Date: 24 April 2026

TPB Ref.: A/YL-KTN/1217

Proposed Temporary Open Storage of Construction Machinery and Construction Materials for a Period of 3 Years at Lot 1750A6 RP (Part) & Adjoining Government Land in D.D. 107, Kam Tin, Yuen Long, New Territories

SWEPT PATH ANALYSIS

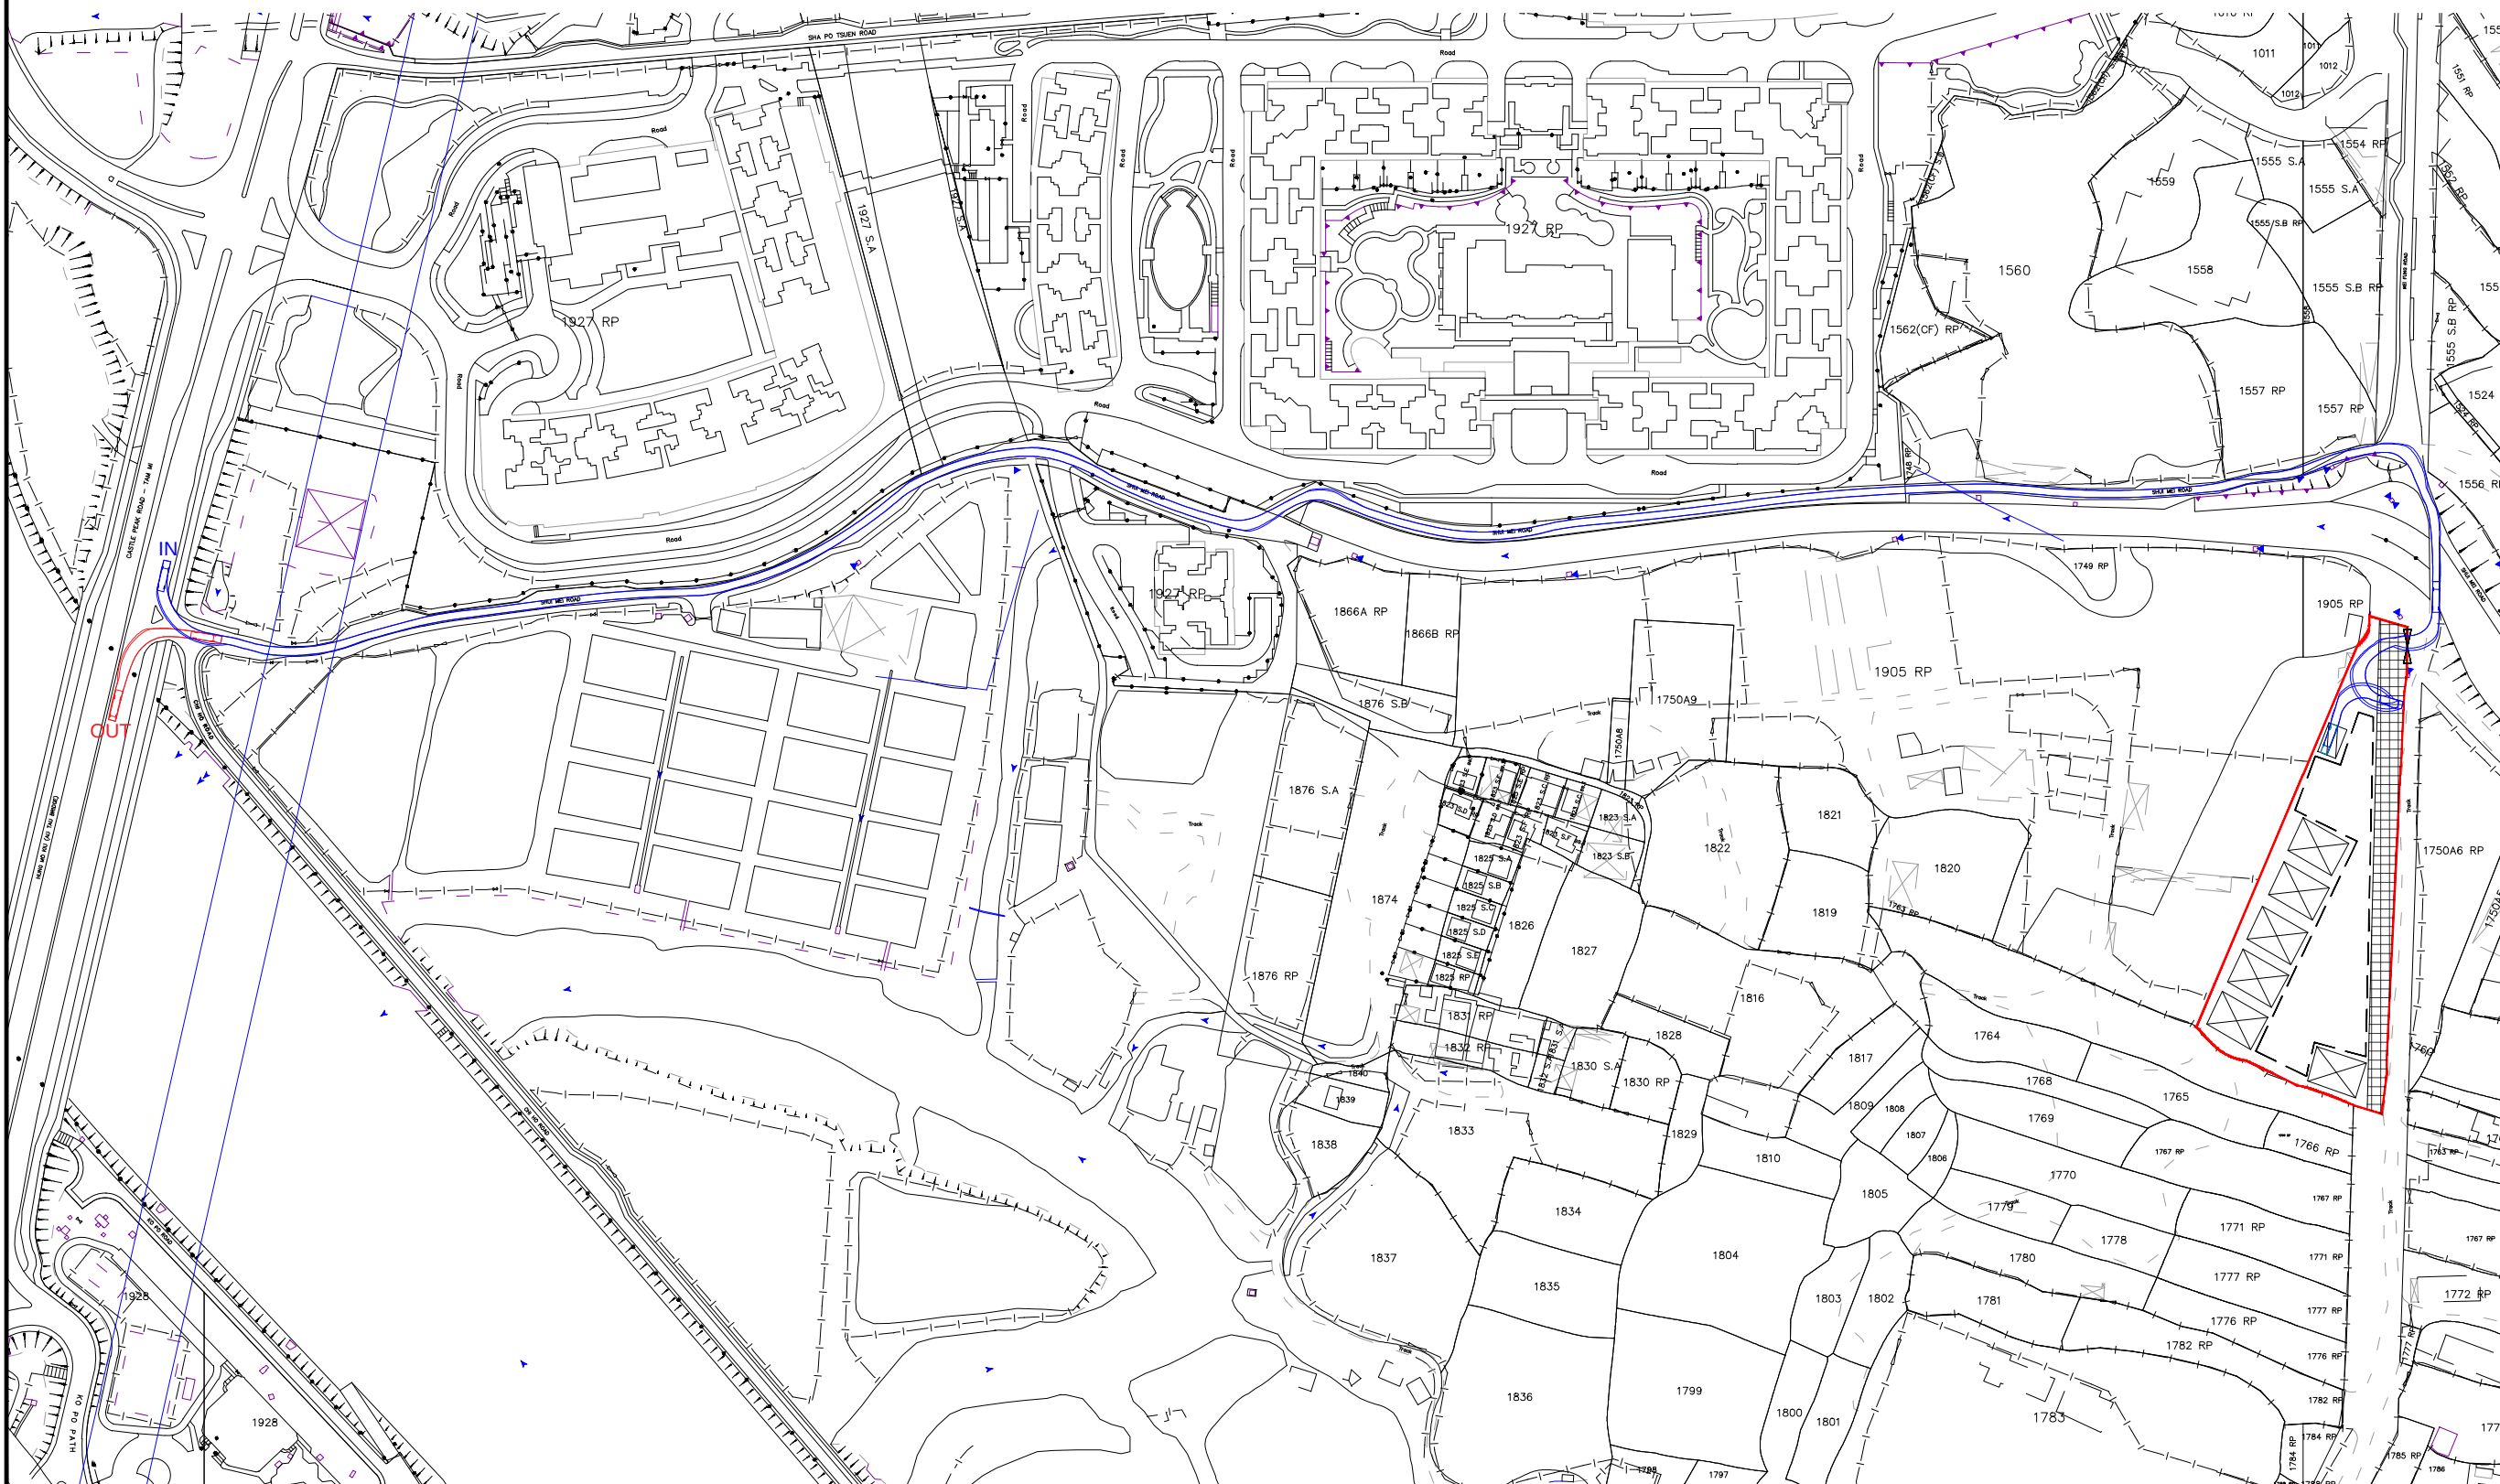
Transport Department's comments	Applicant's response
- The applicant should demonstrate the smooth manoeuvring of vehicles to / from Castle Peak Road - Tam Mi, along the local access and within the site; - The applicant should note the local access between Castle Peak Road - Tam Mi and the site is not managed by his Department.	Please see the swept path analysis in the attachment. Noted.
